ADDENDUM 2
Via E-Mail
DATE: April 13, 2022

Contract: 22-C-00005; Executive Park Gravity Sewer Replacement

Executive Park Gravity Sewer Replacement
Contract: 22-C-00005

C2.4

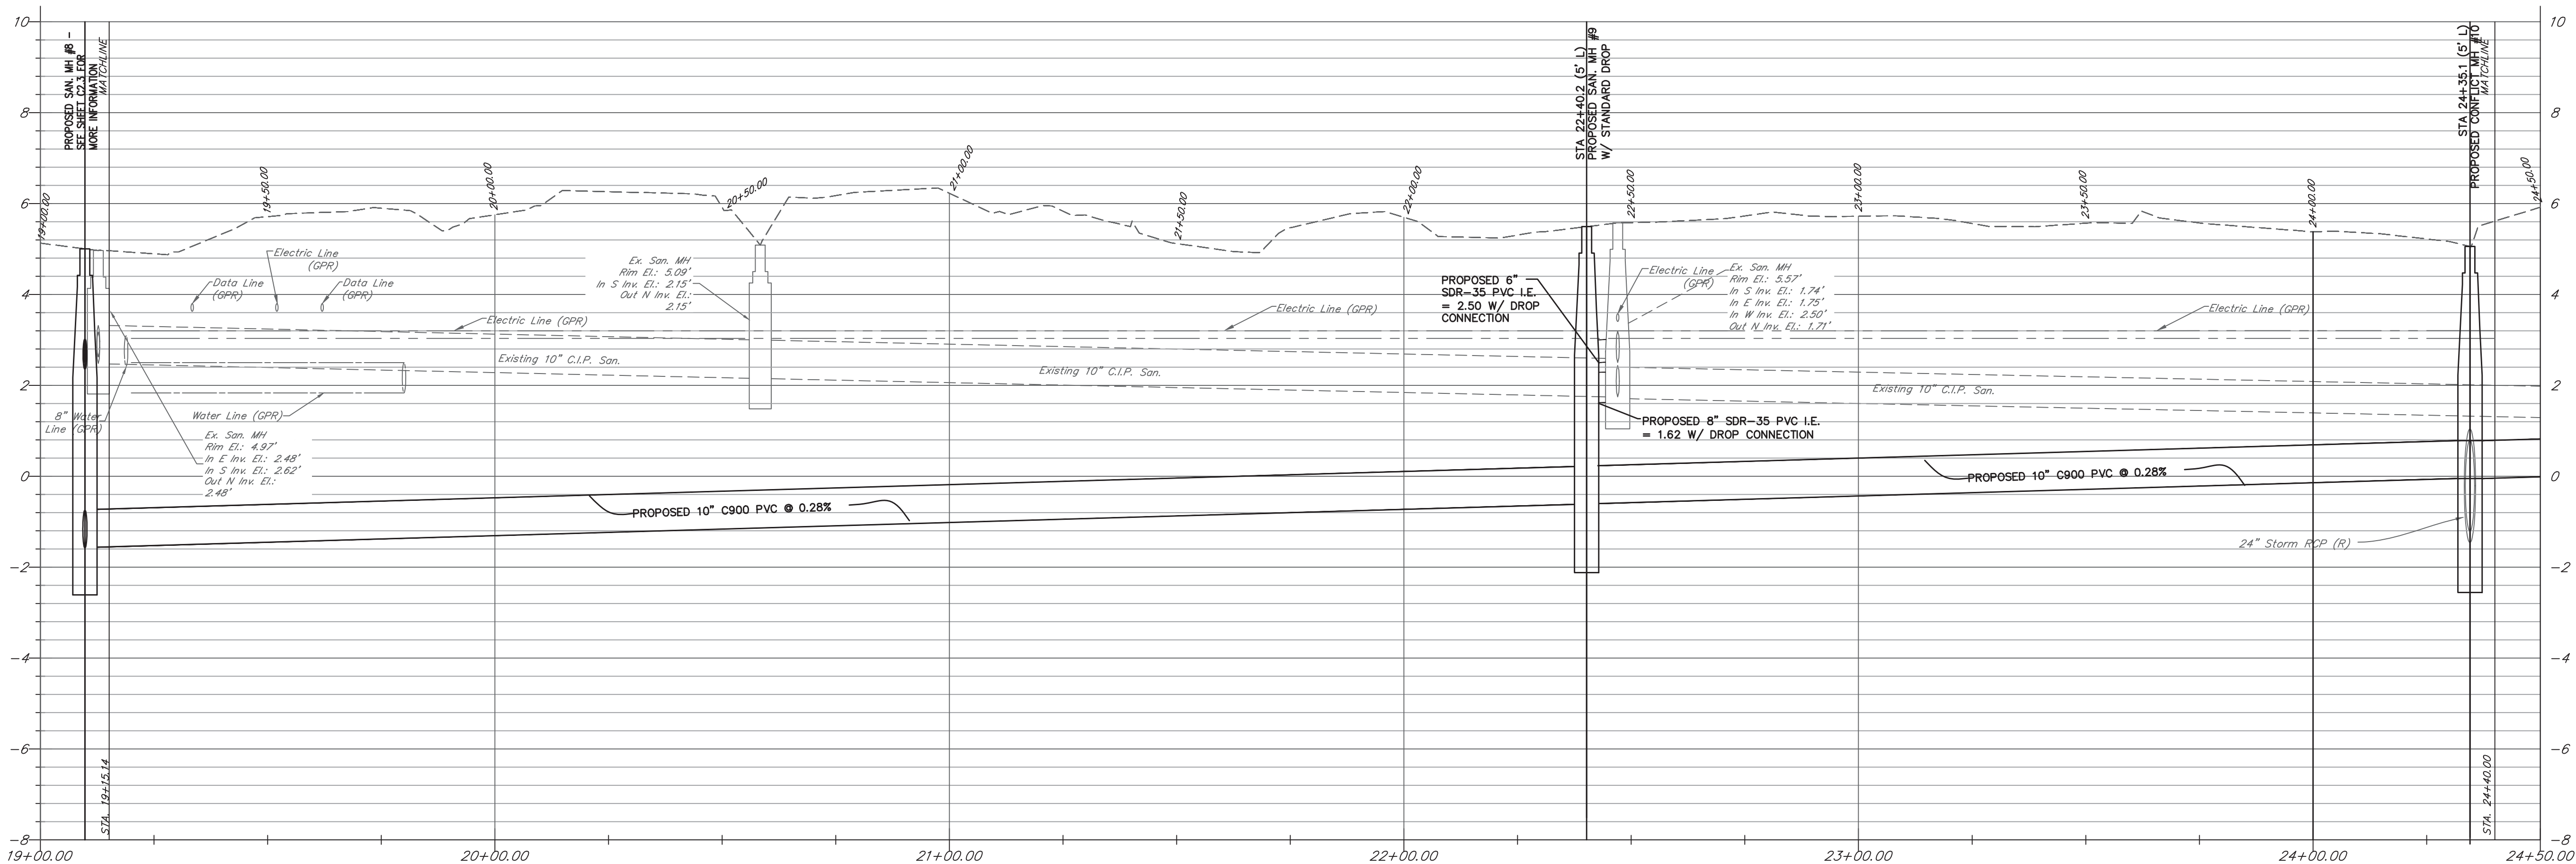
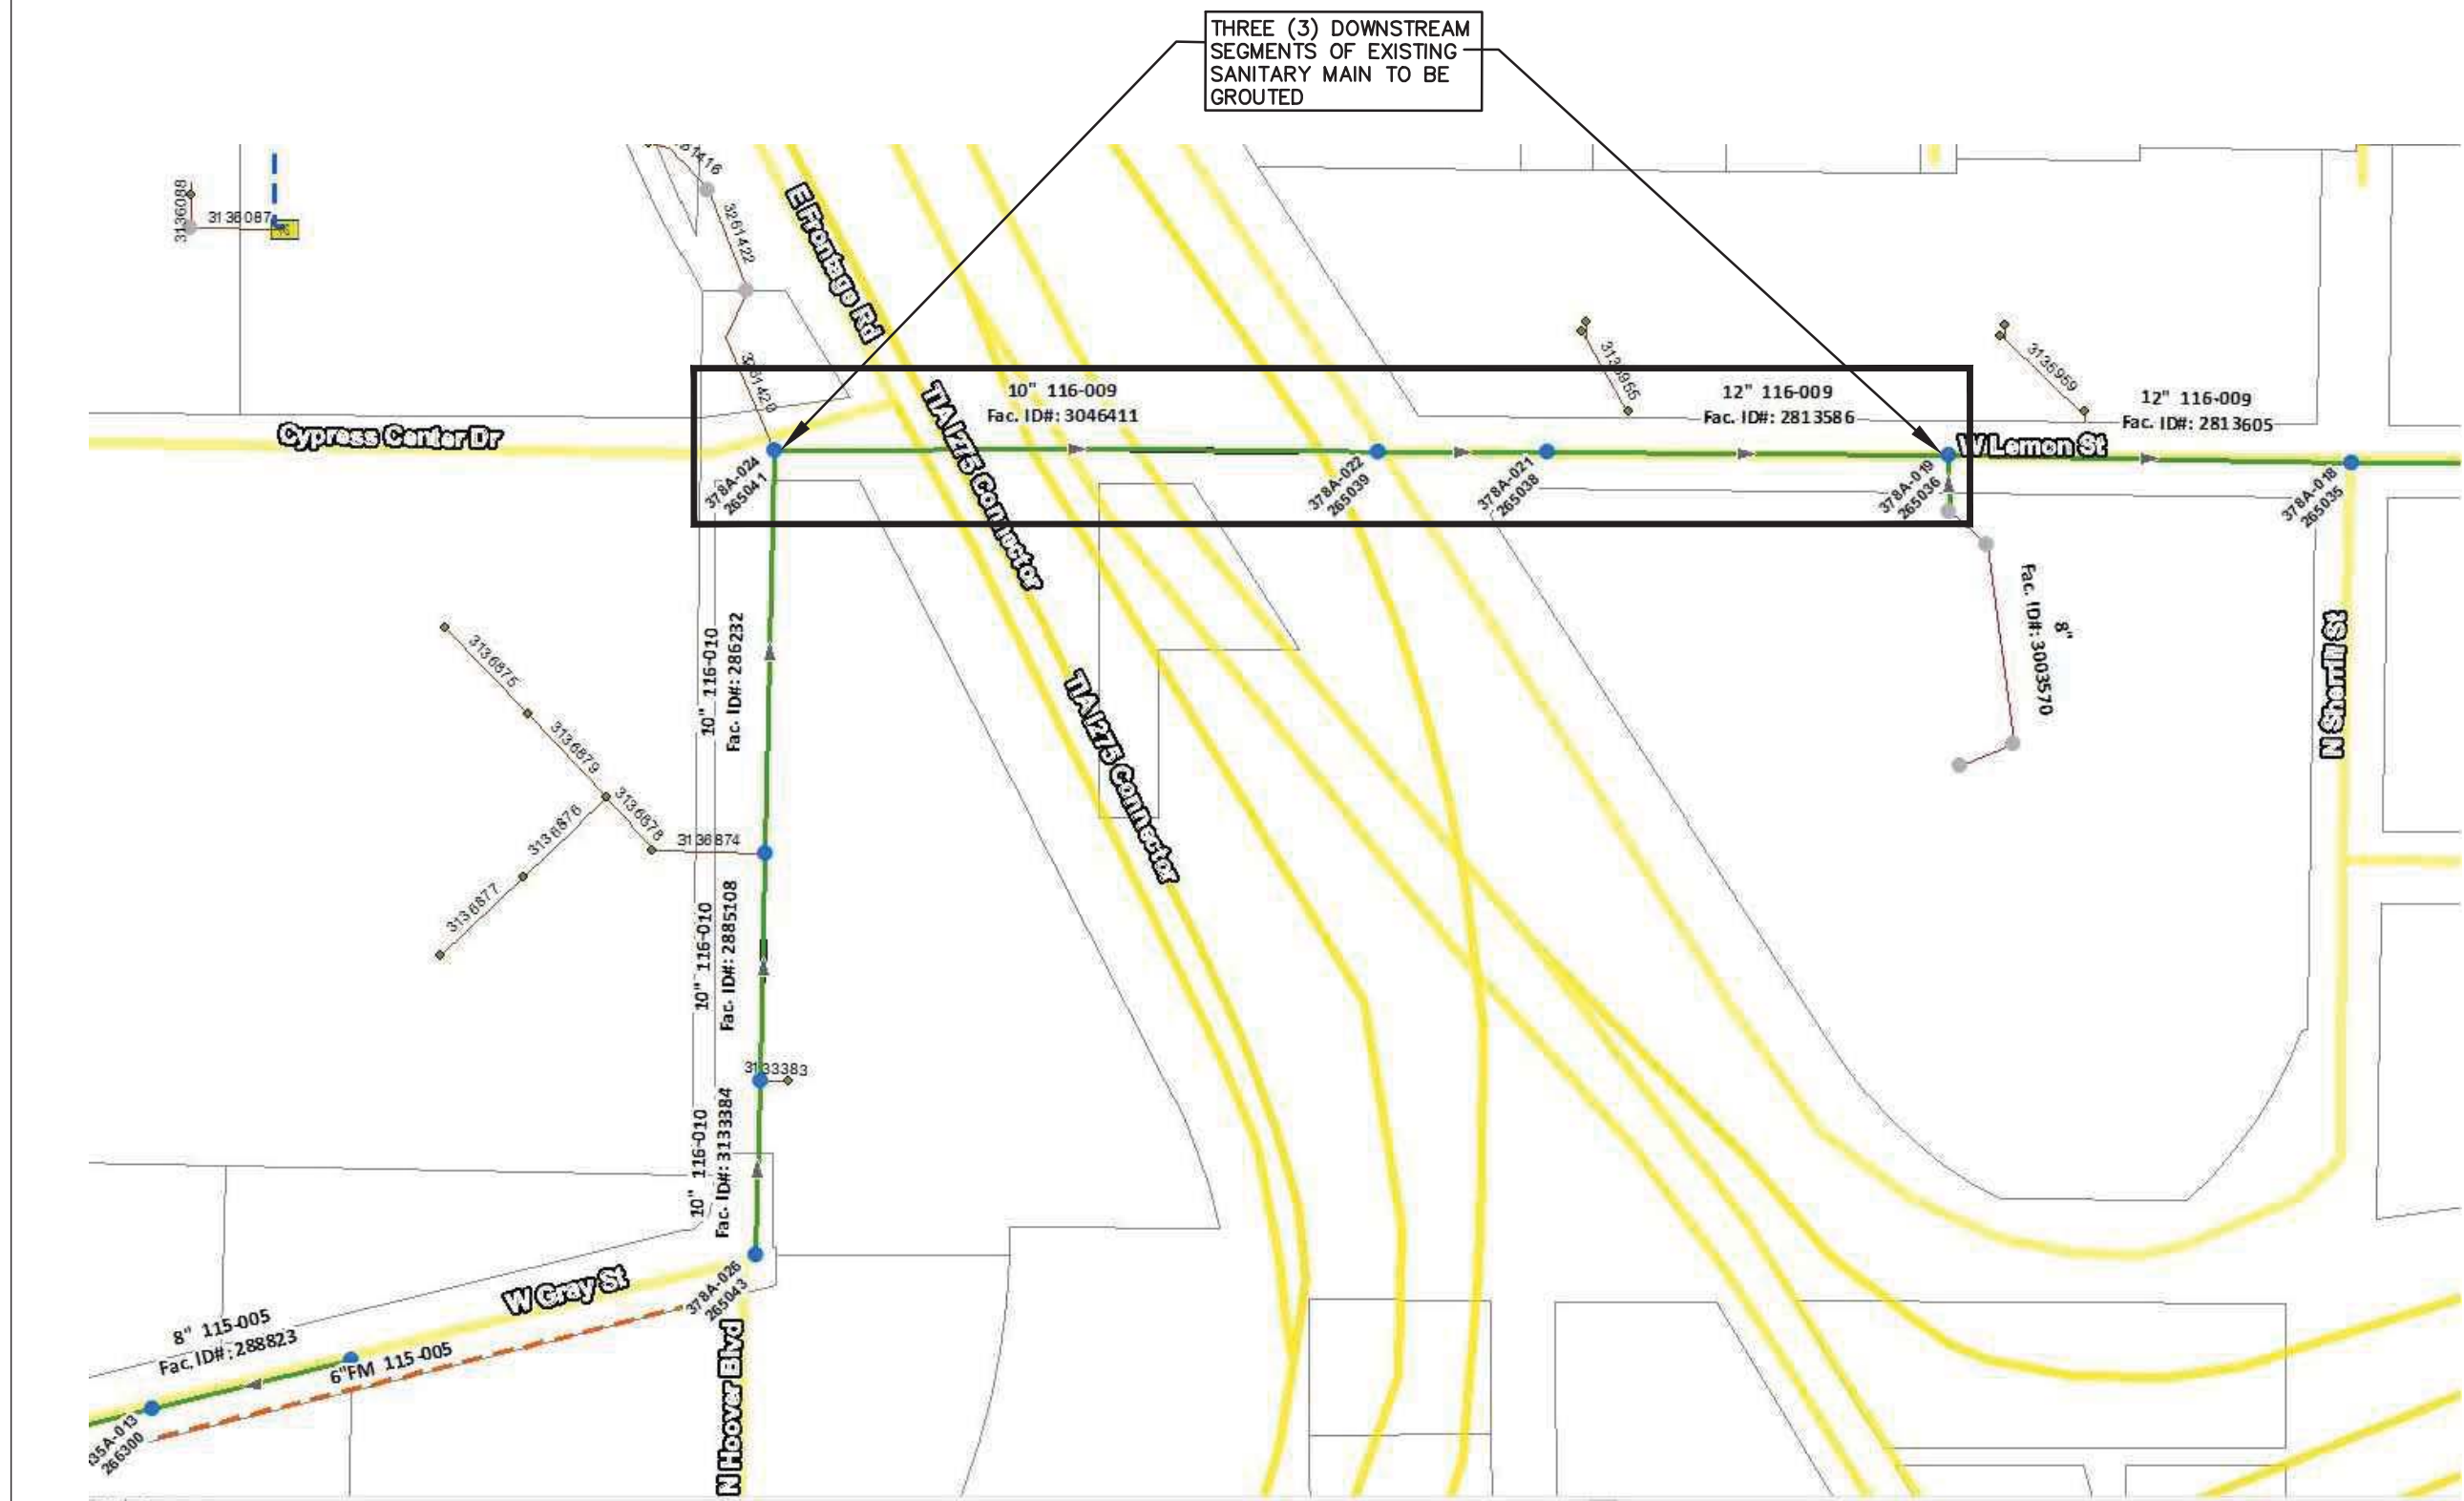
Item 12: Replace plan sheet nos. C2.4 and C2.5 with the attached plans sheet nos. C2.4 and C2.5.

REVISIONS					
BY	DATE	DESCRIPTION	BY	DATE	DESCRIPTION
CVL	3/22/22	10" DIRECTIONAL DRILL PIPE REVISED TO C900

PROJECT	SHEET
EXECUTIVE PARK GRAVITY SEWER REPLACEMENT	C2.5
STA. 24+40.00 TO 25+80.68	JOB NO. 21-013.001

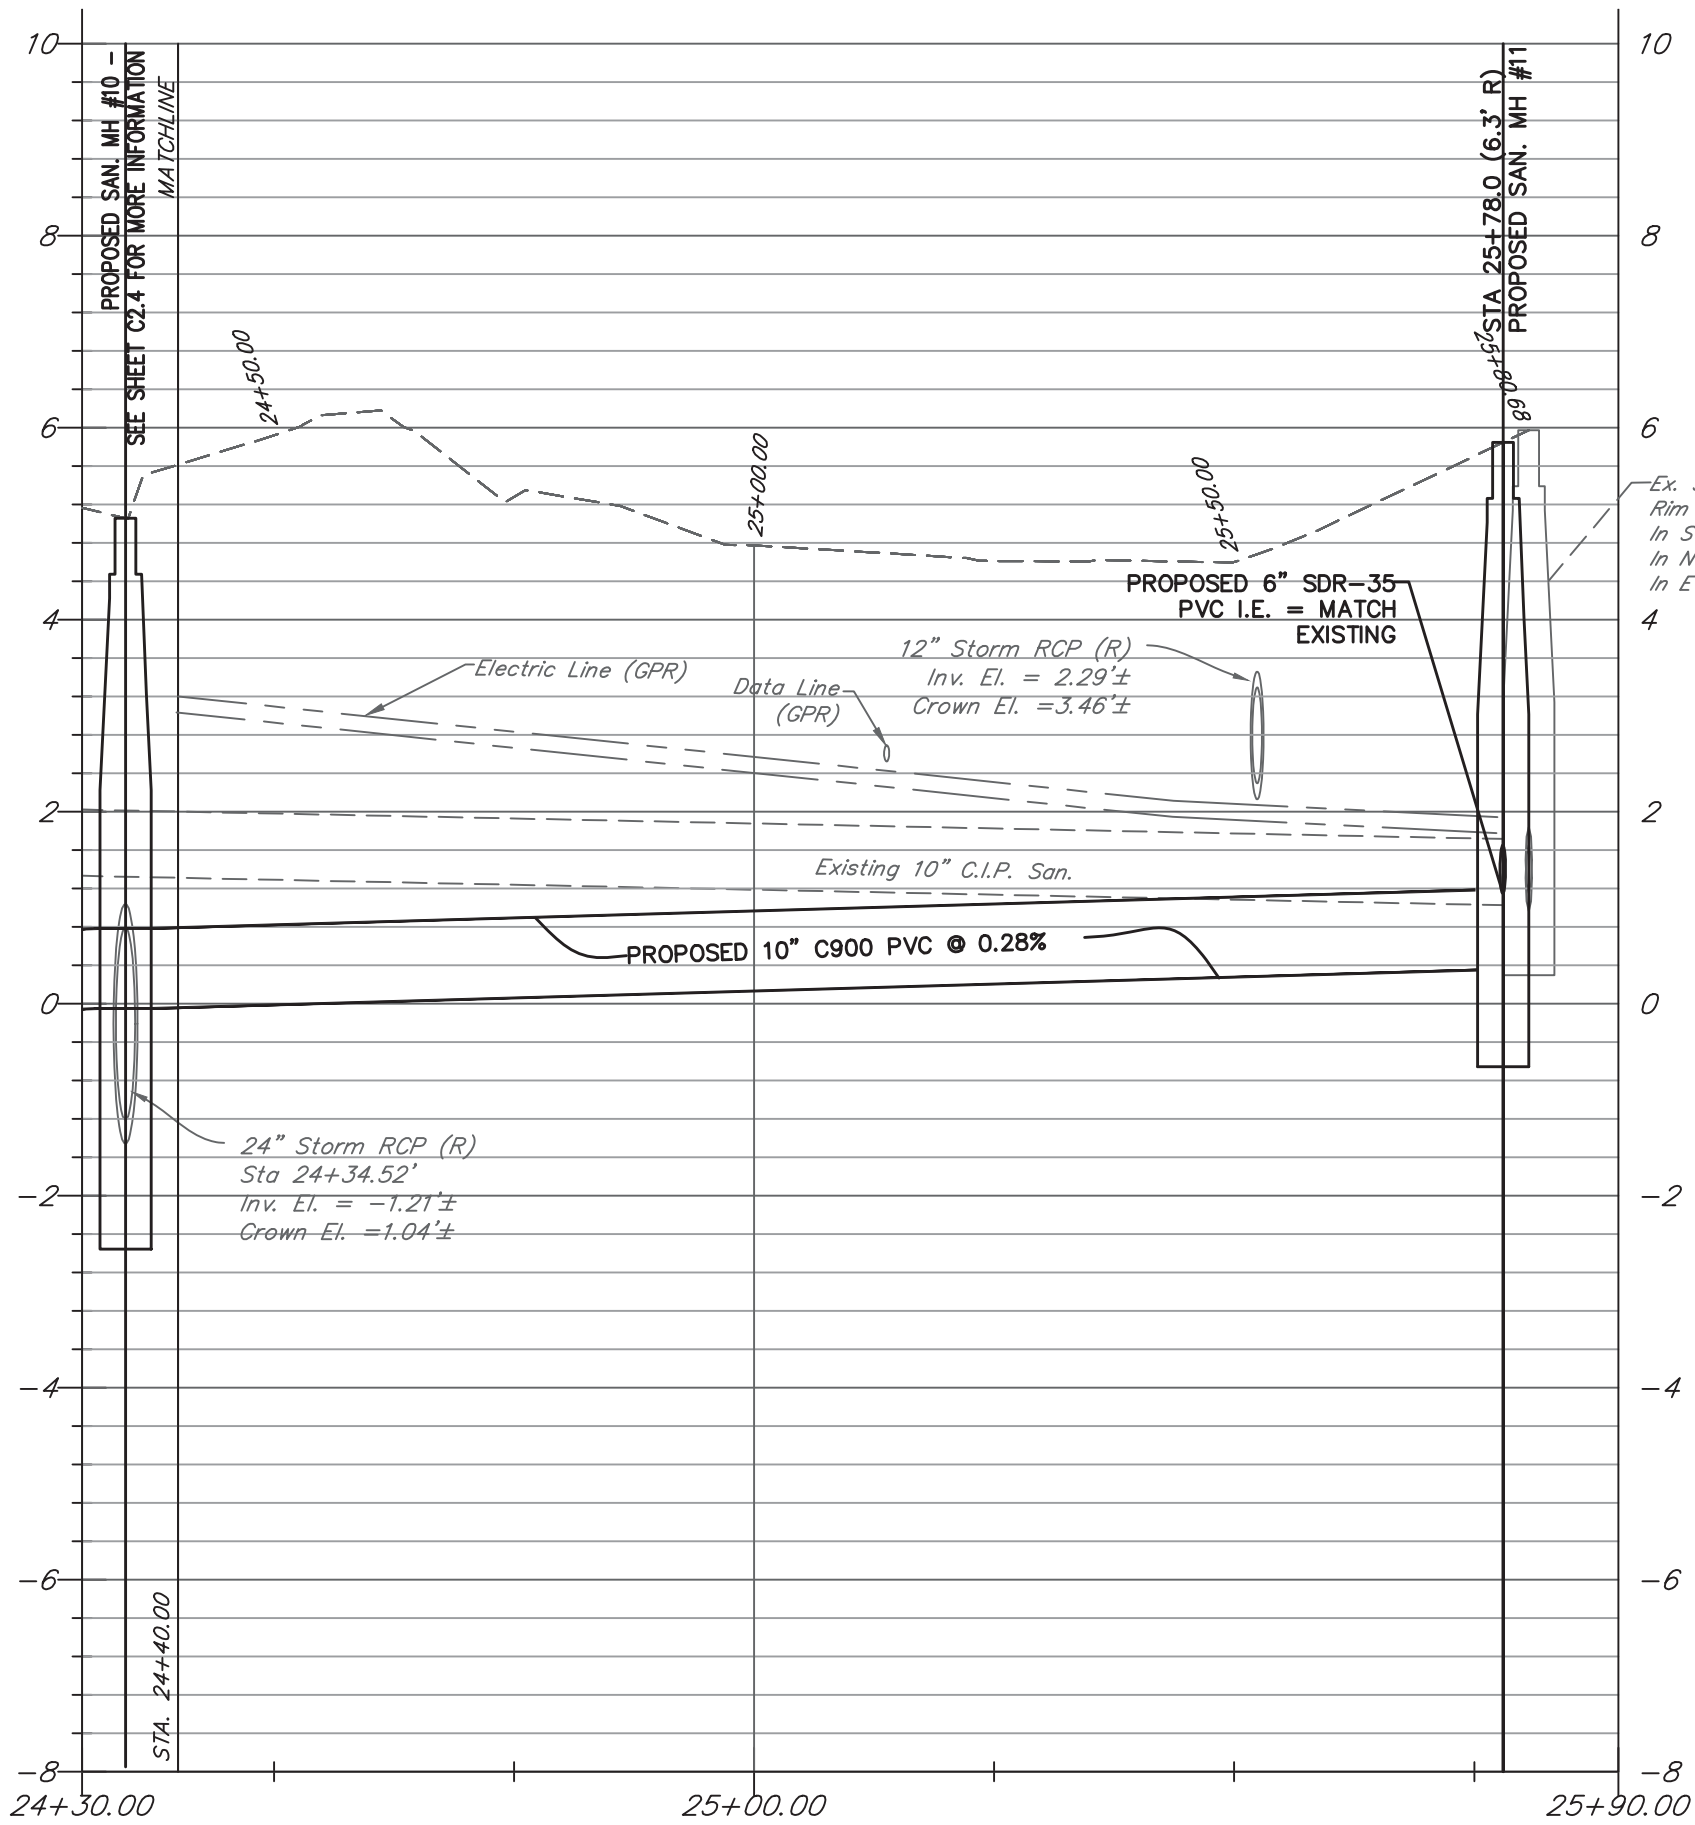
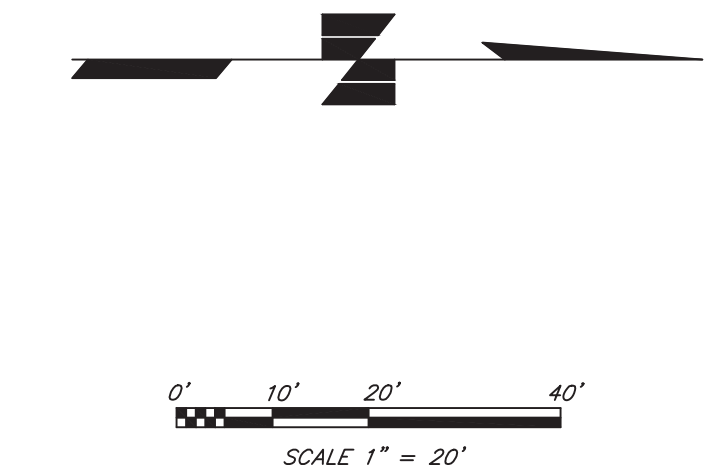
REVISIONS					
BY	DATE	DESCRIPTION	BY	DATE	DESCRIPTION
CVL	3/22/22	10" DIRECTIONAL DRILL PIPE REVISED TO C900
